IN THE MATTER of the proposed Avenue Industrial Private Plan Change (“PC 58”) in Morrinsville

Evidence in Response (Traffic)

Naomi McMinn

26 February 2024

Figure 1 Cycling times from PC58 area – the pointer indicates the new intersection

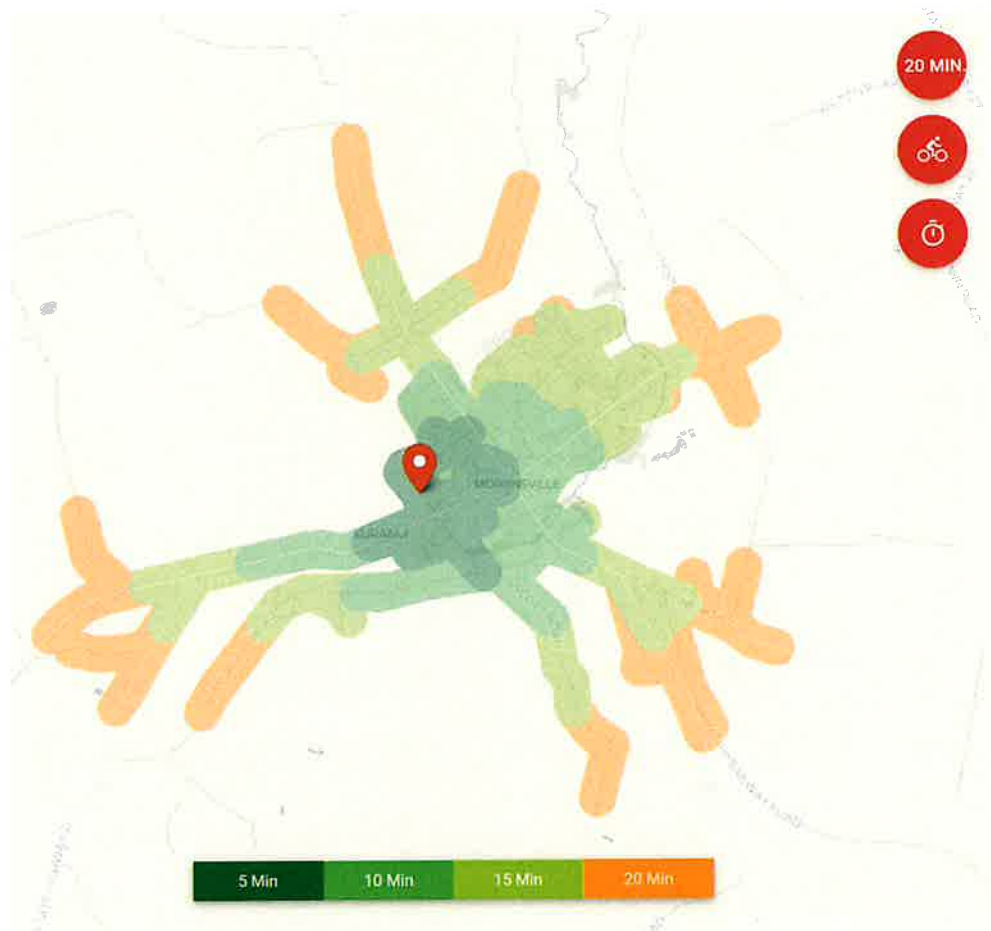
26. The PC58 area is located on the western boundary of Morrinsville. Figure 1 and Figure 2 show the area around the site that is within a five-, 10-, 15- or 20-minute walking and cycling distance³. This shows that there is the high possibility of walking and cycling to the PC58 area by employees or visitors who do not need a car.
27. As development occurs there is likely to be an increase in people walking and cycling in the area, such as between residential areas and employment in the PC58. This is supported by national, regional and local government strategic direction, discussed above.
28. In my view, connections to the wider network and pedestrian crossing facilities on the north-south road and the east-west road should be provided to encourage trips by walking and cycling by providing safe and direct connections.

9.6.1 Transportation Works

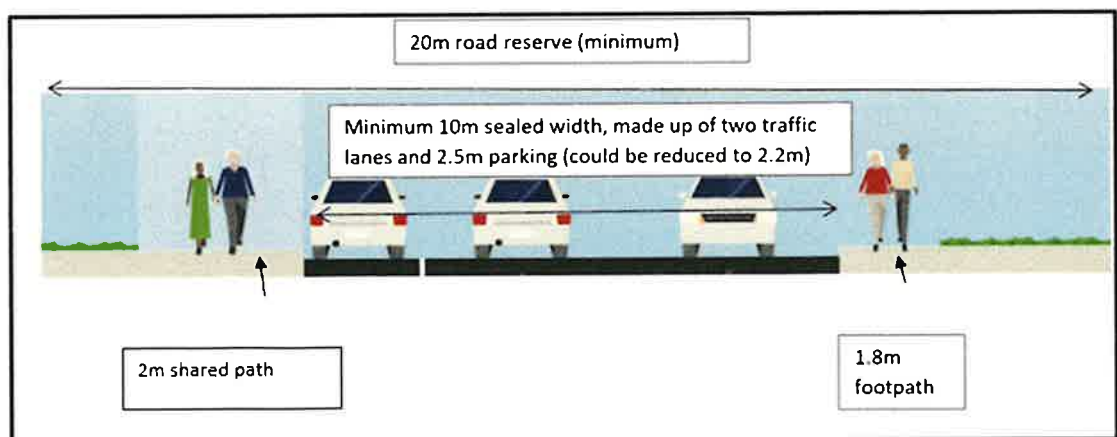
51. I have reviewed the proposed planning provisions and consider the following amendments are required. I recommend changes to the following provisions

below. (Note ~~strike through~~ indicates deletions and underline indicates additional text).

(a) A public road connection to Avenue Road North via Magistrate Avenue, as indicatively shown on the ADAP, and the following improvements to the Avenue Road North/Magistrate Avenue intersection. Detailed design drawings of the intersection upgrade should be subject to detailed design approval by MPDC and include:

- (i) A 3m wide right turn bay, 3.5m wide lanes and 1.5m shoulders on Avenue Road North;
- (ii) A 2m wide pedestrian refuge in accordance with RITS D3.6.4 on Magistrate Avenue; and
- (iii) Vehicle swept paths to confirm the layout is adequate to accommodate heavy vehicles.

(c) All public roads within the ADAP shall be constructed to local road standard with a minimum 20m wide road reserve width, a minimum of 10m wide carriageway made up of two traffic lanes and parking on one side and a minimum 1.8m wide footpath on one side. The north-south road shall include a minimum 2.0m wide shared path on one side and a minimum 1.8m footpath on the other side as indicated on the cross section below. The public roads shall include stormwater provision which may need additional space. Where the landscape buffer is proposed within the road reserve, additional road reserve width shall also be required.

New clause:

(e) The east-west road is to be constructed to match the cross section of the existing Magistrate Avenue within the Avenue Business Park Subdivision with a minimum 20m wide road reserve width, a minimum of 10m wide carriageway made up of two traffic lanes and parking on one side and a shared path (2.0m absolute minimum) on the northern side. The existing footpath along the northern side of the existing Magistrate Avenue within the Avenue Business Park Subdivision is to be upgraded and widened to provide a continuous 2.0m (absolute minimum) wide shared path between Avenue Road North and the PC58 area.
